Merton Council
Development and Planning
Applications Committee
24 August 2023
Supplementary agenda

Planning Applications Committee
24 August 2023
Modifications Sheet

ITEM 5 (565 KINGSTON ROAD, RAYNES PARK SW20 8SA)

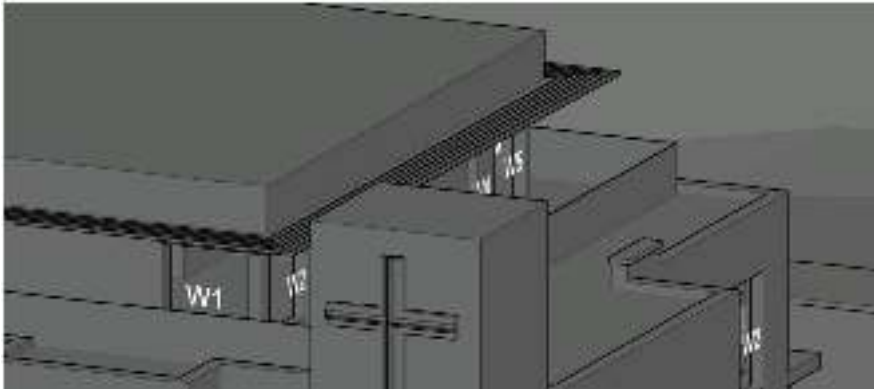
27, Please explain in (A) plain English including actuals and (B) provide the underlying calculation relating to mean weighted average reduction factors.

We have asked the applicant to provide this. I do not know the underlying calculation, and would not have the expertise to interpret it, but essentially it seeks to assess the combined impact of all the windows to a room.
